PROPOSAL, CONTRACT, BOND AND SPECIFICATIONS

PARK PAVING 2021

CONTRACT NO. 9039

Revise and amend the contract document(s) for the above project as stated in this addendum, otherwise, the original document shall remain in effect.

SHEET NUMBER:
1.0

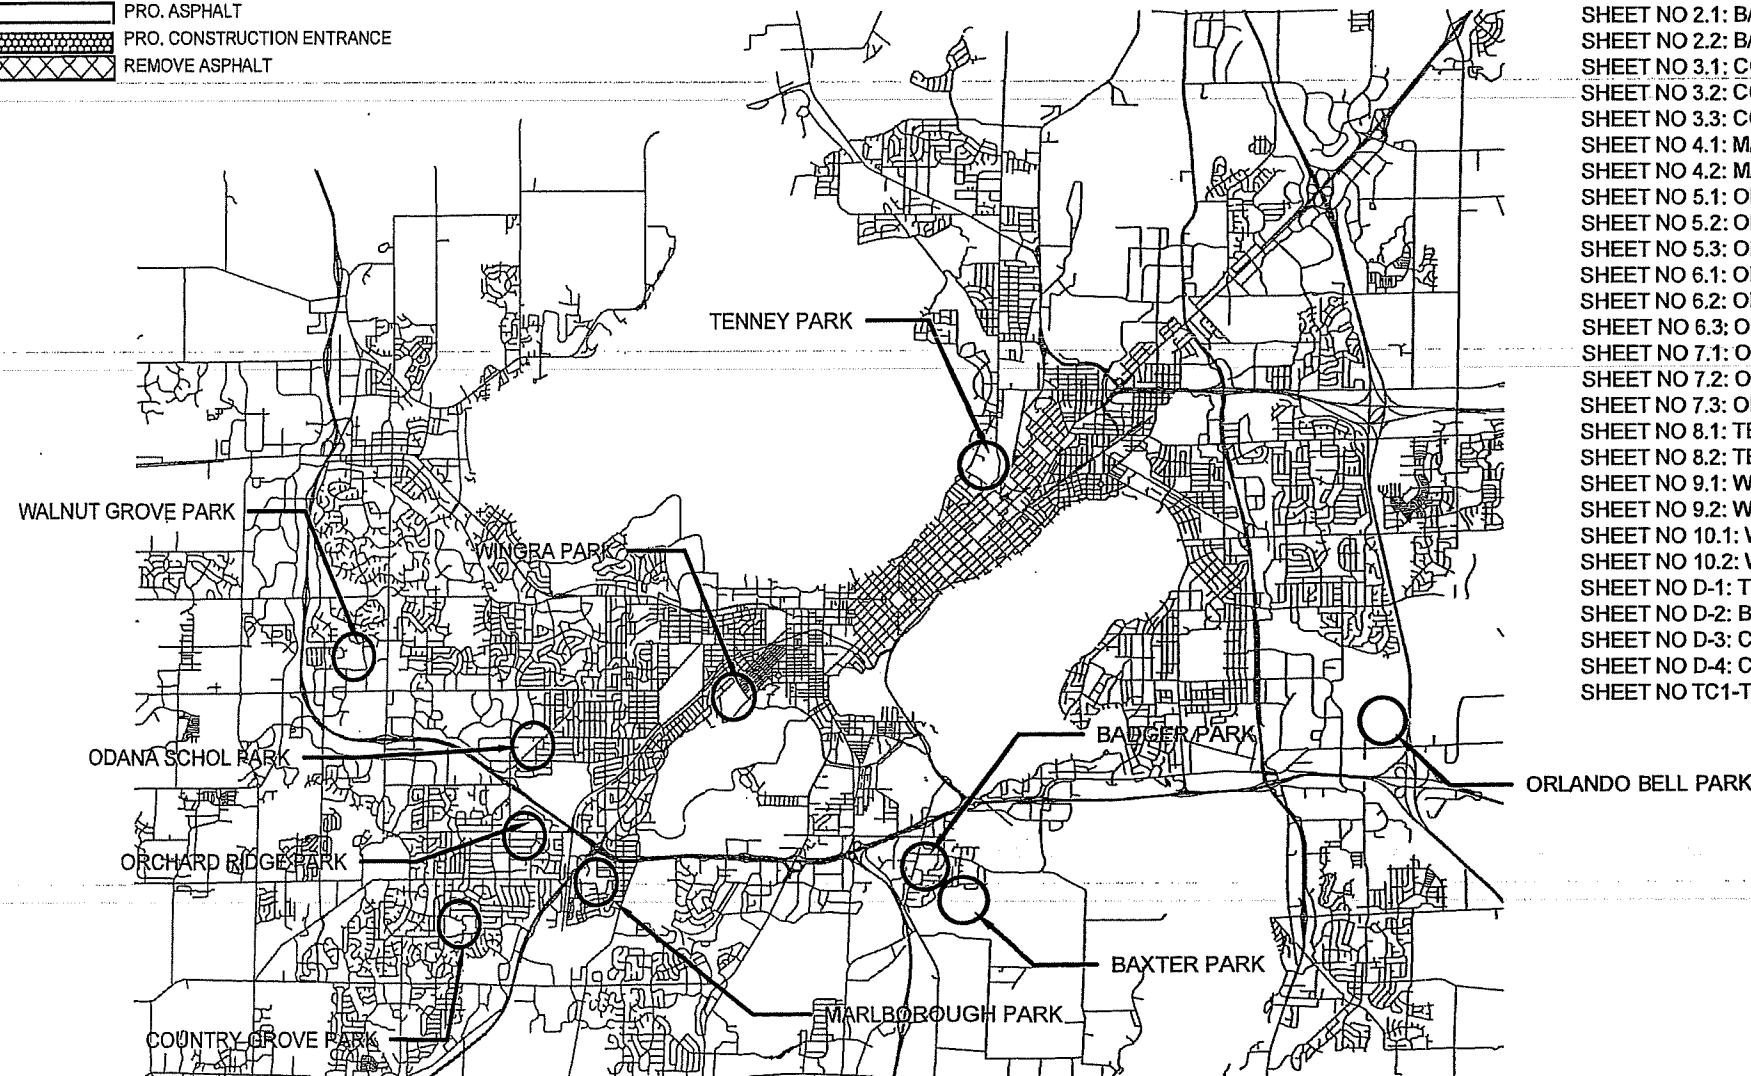
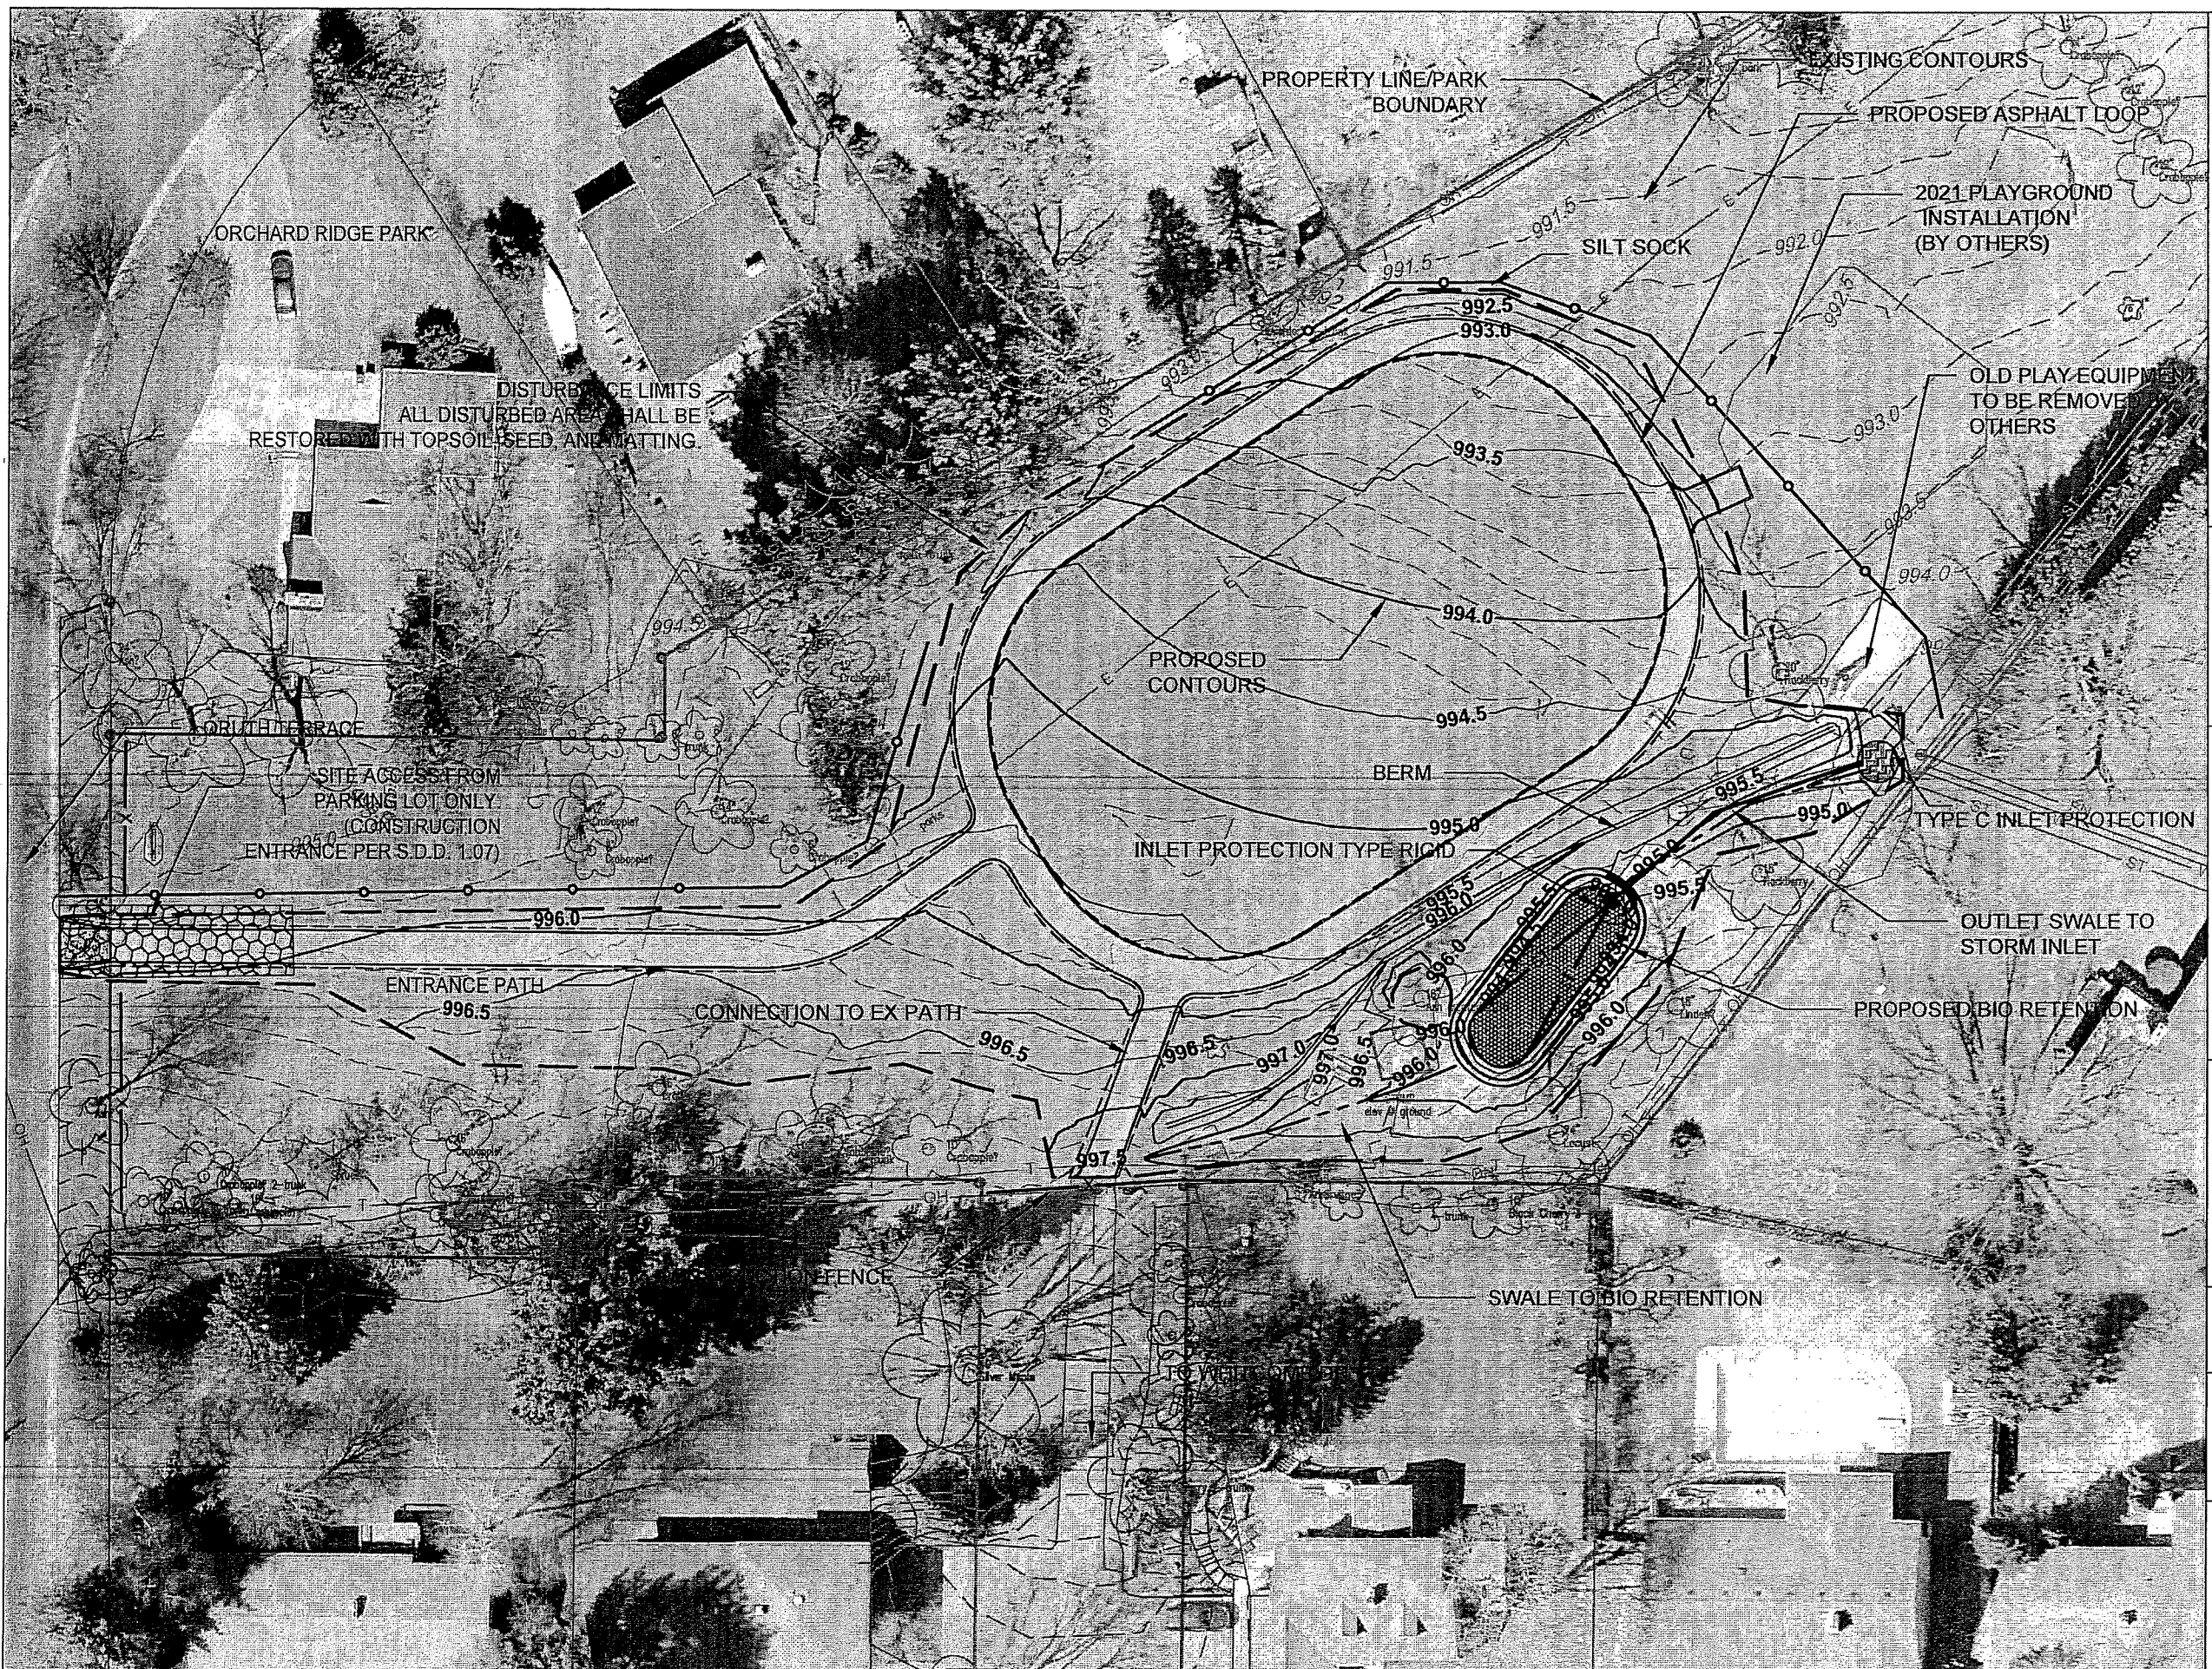
- Sheet 1- Title – Add Sheet 6.3 to page numbering
- Add Sheet 6.3- Orchard Ridge Bio Retention
- Revise Sheet 6.1- Orchard Ride Site Access and Erosion Control
- Revise Sheet 6.2 – Orchard Ridge Grading
